Bayside Local Planning Panel

Application No DA-2025/54

Property 18 Hambly Street, Botany

BAYSIDE COUNCIL Planning Assessment Report

Figure 7 – existing street tree, power pole and applicant diagram

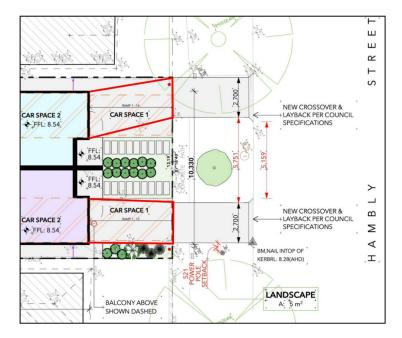
A related issue to the street tree removal is the placement of the driveways and impacts on availability of street parking. The Council's original engineering referral response suggested the driveways should be a maximum of 2.7m, with suitable power pole setback, and set further apart (5.9m), to allow a full on-street car space meeting Australian Standards, between the driveways. This was included in a RFI to the applicant.

In response to the RFI, the applicant reduced the driveway widths from 3m to 2.7m, but advised when accounting for the required clearances from the existing telegraph power pole, 5.9m separation between driveways was not possible, even pushing the eastern driveway to the eastern side boundary (5.751m achieved, and 5.16m at the kerb line allowing or splays). So, the applicant retained a 931mm setback from the eastern boundary in the latest plans, to not "reduce landscaping" and "not detract from the residential amenity and local character" by otherwise aligning to the eastern boundary.

I am happy with the amended stormwater plans subject to conditions. However, I need the driveways adjusted to help preserve on-street parking. The plans need to be amended to reflect the below mark-up, the red shows the driveway extent require which will still allow for landscaping or the driveways or alternatively, this can be conditioned.

The comments from both the Council's tree officer and engineer are entirely reasonable, noting the recommended driveways allow maximum separation to benefit the existing street tree and

The applicant was afforded a further opportunity to accept a condition or provide further arguments against the street tree retention. If arguing against the street tree retention and given a different opinion about the ability to retain the street tree between the Council and applicant expert, the applicant was requested to provide updated advice from their arborist confirming, or otherwise, the need for the tree removal, given the reduced width and relocation of driveways, with consequent changed and reduced tree impacts. The applicant provided further arguments about retaining the street tree, providing evidence of blockage of sewer pipes by the existing street tree. However, the applicant was unable to secure definitive advice from their arborist about the ability to retain the street tree.

Figure 10 - Flood Map extract

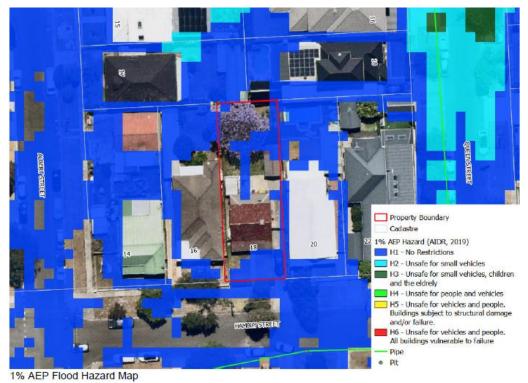
Council records indicate that the lot is subject to partial flooding in a 1% AEP, as shown in the map extract below:

The level of the 1% AEP flood is RL 8.1 (PMF = 8.26). Parts of the front of the site are slightly

below RL 8.1. The Council's flood planning level for dwellings (not garages) is 500mm clearance above the 1% AEP, being RL 8.6.

The proposal adopts a habitable floor level of RL 8.62, slightly elevated compared to current levels and compliant with the flood planning level.

Figure 12 - First Floor Plan Extract

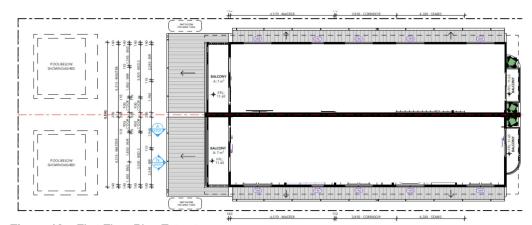
The proposed development has been designed and sited to reasonably minimise overlooking to and from adjoining properties. The privacy impacts are considered acceptable, subject to conditions requiring:

- The side screens to the first-floor balconies being fixed; and
- At first floor to the side elevations, provide highlight windows with a minimum sill height of 1.5 metres or fixed translucent glazing to windows below 1.5m.

- The side privacy screens to the first-floor rear balconies shall be fixed and annotated as such on the Construction Certificate Plans, consistent with the approved DA plans, and installed as such to avoid lateral privacy impacts to neighbours.

- At first floor to the side elevations, plans shall confirm highlight windows with a minimum sill height of 1.5 metres above finished floor level, or fixed translucent glazing to windows below 1.5m.

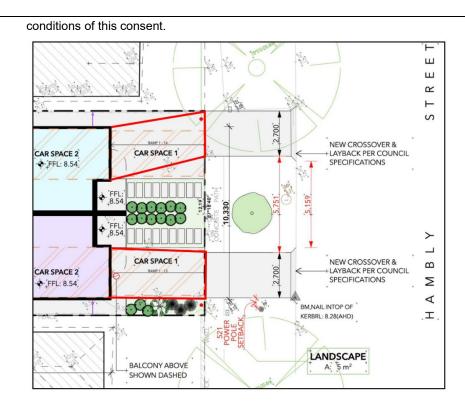
1. Before the issue of a construction certificate and in addition to the Landscape conditions in this consent, the plans must be amended to revise the driveway crossing to be consistent with the plan below, marked up in red. This is to occur while retaining the existing street tree, following written recommended measures by a qualified arborist. The driveways must be separated by at least 5.75m. The driveway widths must be also be 2.7m wide and the locations redesigned to provide the required separation to comply. Also, a setback of minimum 0.5m is required between the driveway access and the power pole. This shall also be consistent within an application to Council under the Roads Act 1993, and include other appropriate upgrades to the public domain and appropriate bonds, required by other
